Access Compliance Report

Public Rights-of-Way

(Curb Ramps)

Intersection ID: 15675	Main Street: EAST_BV	Cross Street: LOMBARDY_CR	Location: NE
ADA ID: 79ECE4AF53D1	Ramp Type: PerpDiag	Initial Pass/Fail: Pass	Overall Compliance: No
Severity Score: 12.5			
Codes/Mitigation Info/Possible Solution		Field Measurements/Component Compliance

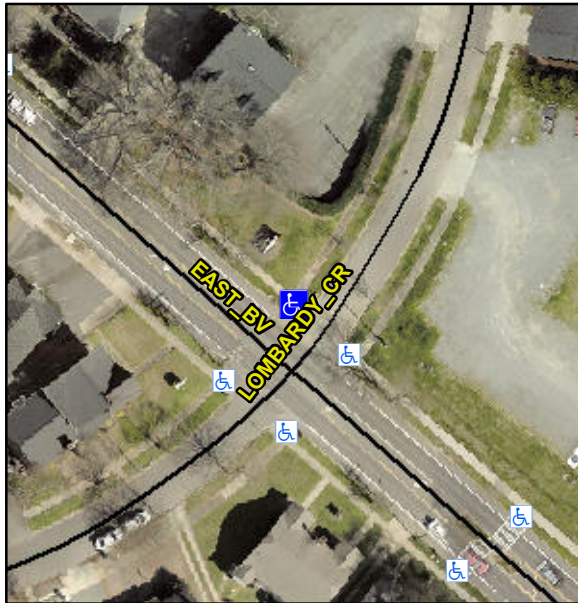
Not Found, R304.2.2, R304.2.1, R304.2.2-Perp, R304.3.2-Para, R304.5.3, R305.2

Compliance	Description	Data	Compliance	Description	Data
N/A	Ramp Length (in)	111.0	No	Ramp Slope (%)	8.8
Yes	Ramp Width (in)	48.0	Yes	Ramp XSlope (%)	1.1
N/A	Flare Type LT	None	N/A	Flare Type RT	N/A
N/A	Flare Slope LT (%)	N/A	N/A	Flare Slope RT (%)	N/A
N/A	Flare Traversable LT?	N/A	N/A	Flare Traversable RT?	N/A
No	Landing Length (in)	N/A	Yes	DWS Provided?	Yes
No	Landing Width (in)	N/A	Yes	DWS Contrast?	Yes
No	Landing Slope (%)	N/A	Yes	DWS Length (in)	24.0
No	Landing X Slope (%)	N/A	Yes	DWS Full Width?	Yes
N/A	Landing Curb? (Y/N)	No	No	DWS Offset (in)	4.0
N/A	Shared Landing?	N/A			
Yes	Gutter Ponding?	No	Yes	Gutter Slope (%)	0.4
Yes	Gutter Lip Ht (in)	0.0	Yes	Gutter X Slope (%)	1.2
N/A	Painted X Walk1?	No	N/A	Painted X Walk2?	No
	X Walk 1 Direction	To SW		X Walk 2 Direction	To SE
N/A	X Walk 1 Width (in)	N/A	N/A	X Walk 2 Width (in)	N/A
	X Walk 1 Slope (%)	3.0		X Walk 2 Slope (%)	0.9
	X Walk 1 X Slope (%)	0.2		X Walk 2 X Slope (%)	2.4

Remove & Replace Curb Ramp With Two New Directional Ramps or Equivalent.
